City of Sandy

Planning Commission Meeting

Meeting Date: Monday,
September 27, 2021

- 8.2. 21-014 SUB/TREE: Deer Meadows Subdivision 93 - 867
[Staff Report for Deer Meadows Subdivision](#)
[Exhibits A-B for Deer Meadows](#)
[Exhibit C for Deer Meadows](#)
[Exhibits D-E for Deer Meadows](#)
[Exhibits F-J for Deer Meadows](#)
[Exhibits K-L for Deer Meadows](#)
[Exhibits M-R for Deer Meadows](#)
[Exhibits S-W for Deer Meadows](#)
[Exhibit X Letter from Michael Robinson](#)
[Exhibit Y Letter from Michael Robinson \(Sep. 24\)](#)
[Exhibit Z Letter from All County Surveyors and Planners \(Sep. 16\)](#)
[Exhibit AA Parks and Trails Advisory Board Minutes](#)
[Exhibit BB Public Comment - Dave Carter \(Sep. 27\)](#)
[Exhibit CC Revised TIS from Ard Engineering \(Sep. 27\)](#)
[Exhibit DD Public Comment - Vincent & Lynn K Mandina \(Sep. 27\)](#)
[Exhibit EE Ard Engineering Response Memo \(Sep. 27\)](#)

STREET TREE PLAN & PARKING ANALYSIS

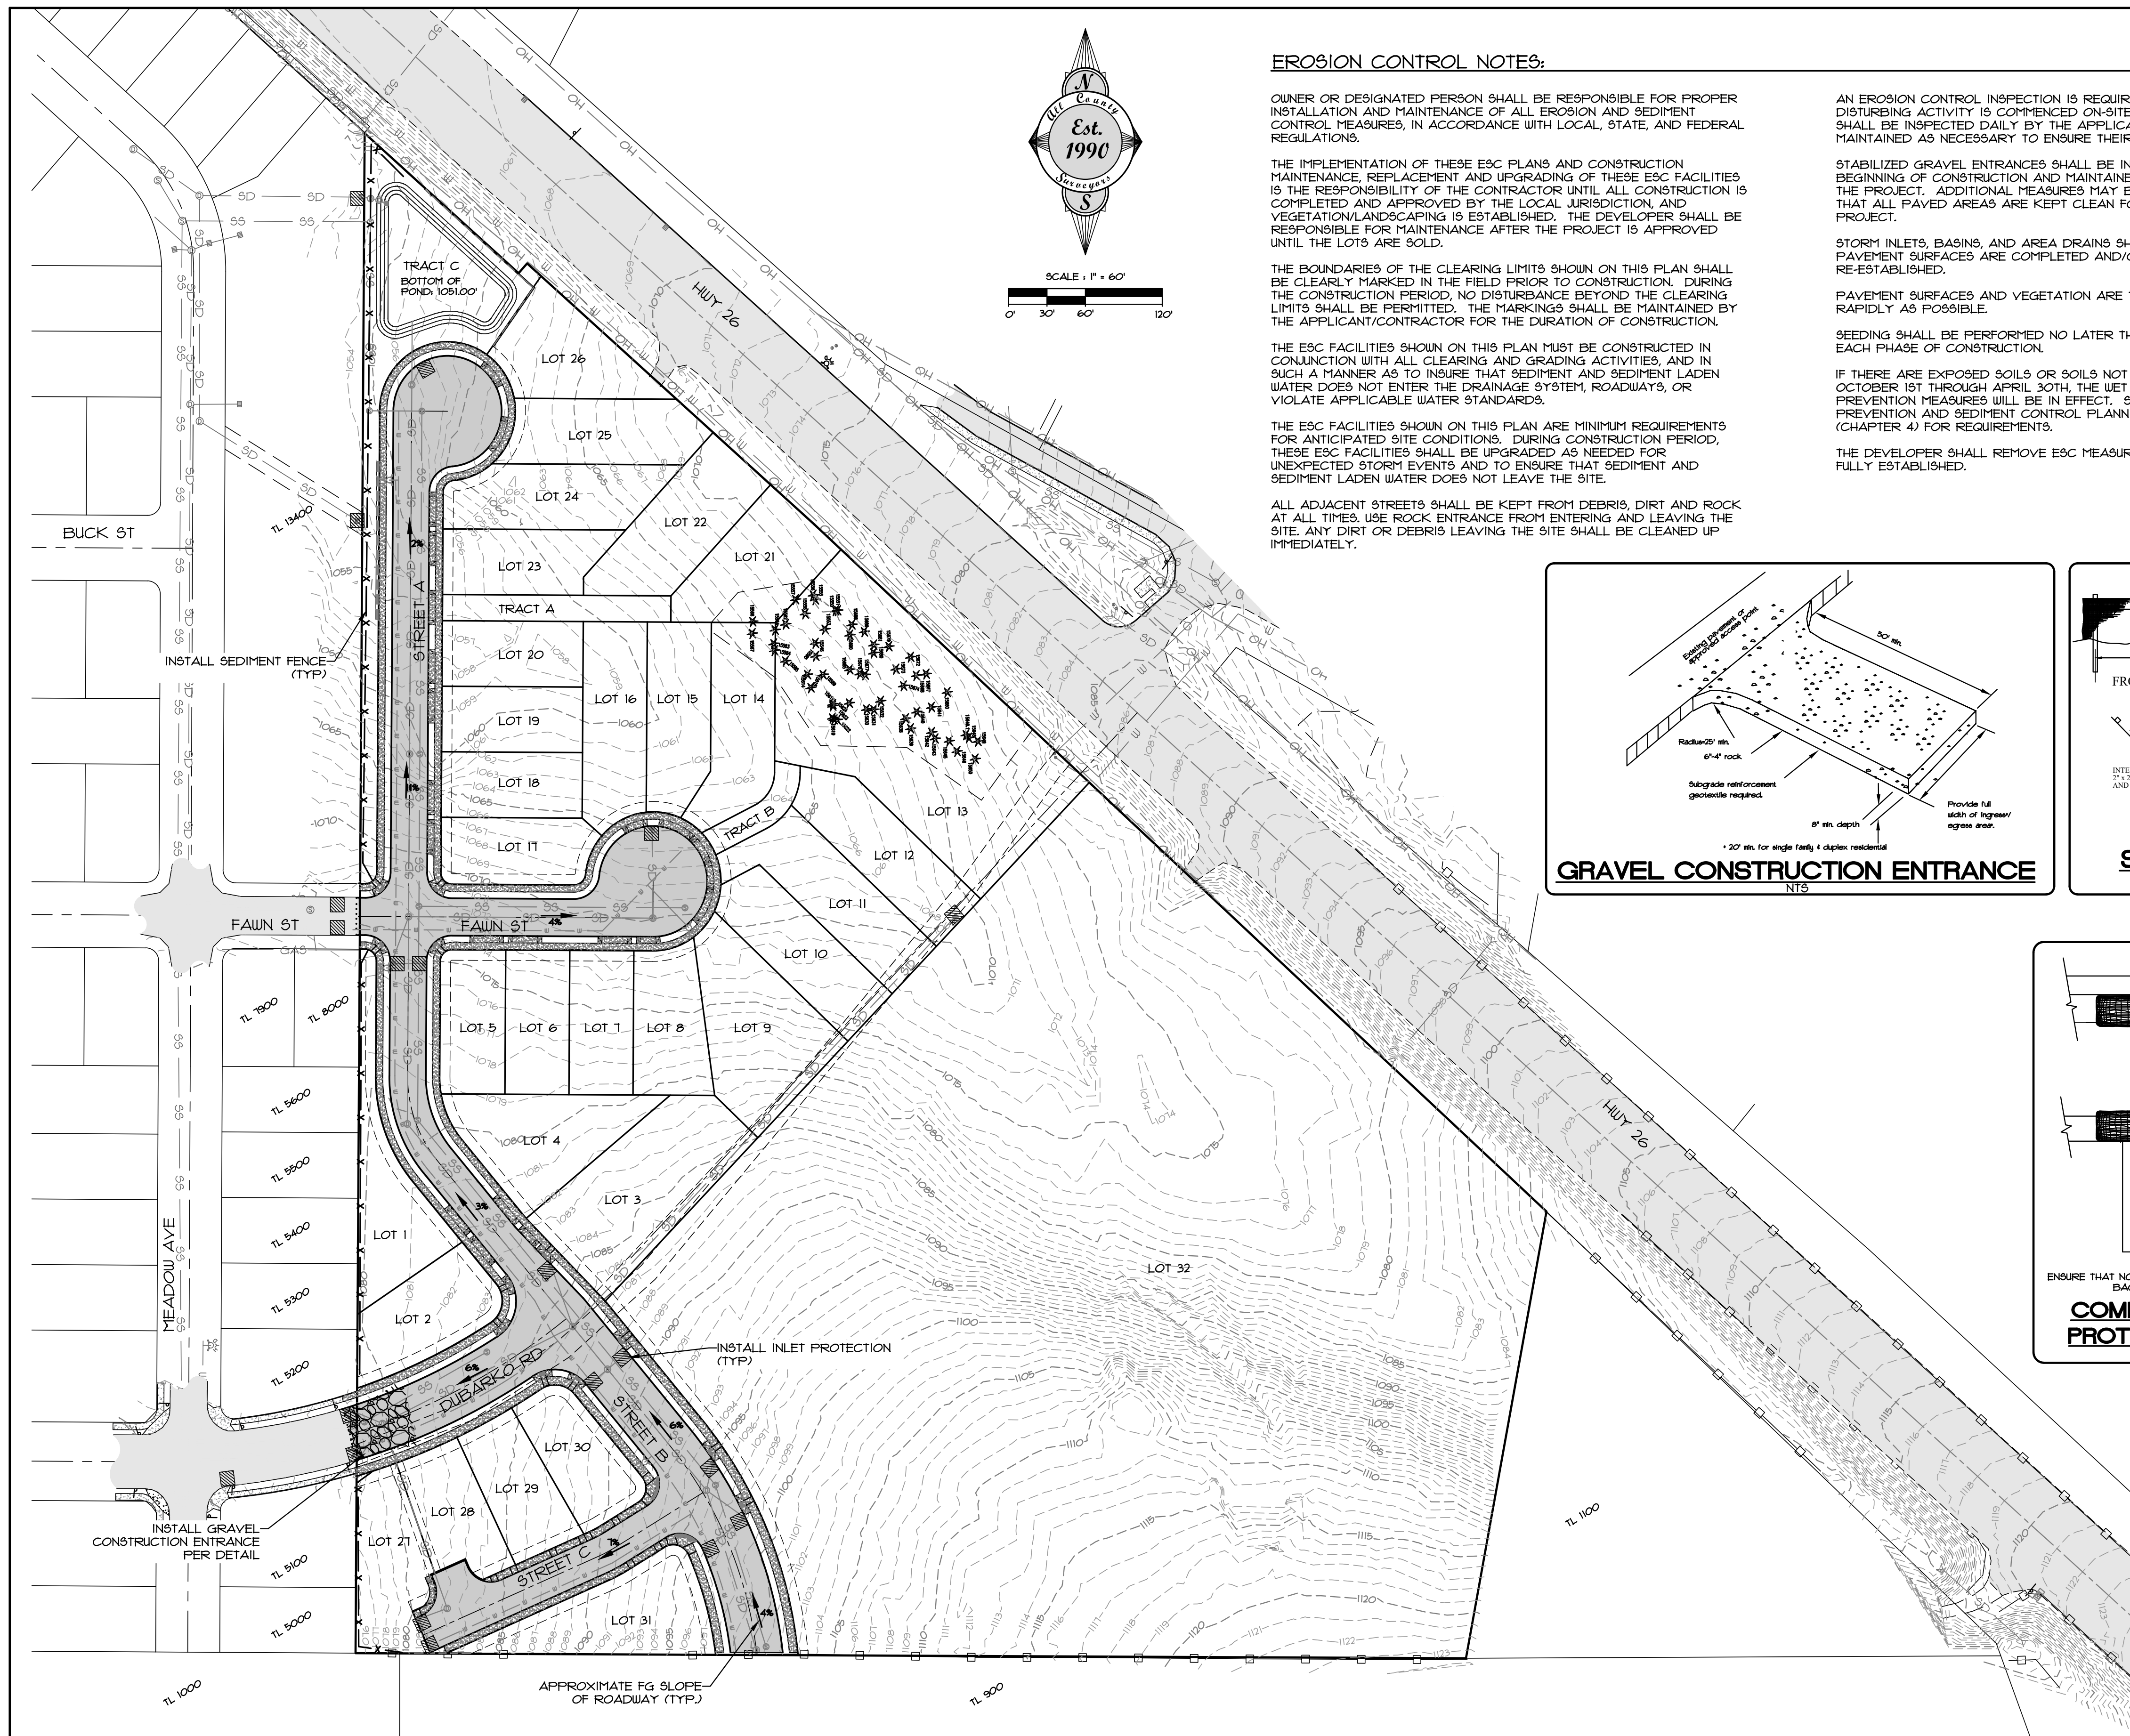
55. Section 17.98.10(M) requires that the developer provide a Residential Parking Analysis Plan. This plan identifying the location of parking for the 30 R-1 zoned lots is included in Exhibit C, Sheet C6.

has been identified within 300 feet of each of the 30 lots zoned as R-1 as required. Exhibit C, Sheet C6 shows that 47 on-street parking spaces have been identified in compliance with this standard. No parking courts are proposed by the applicant.
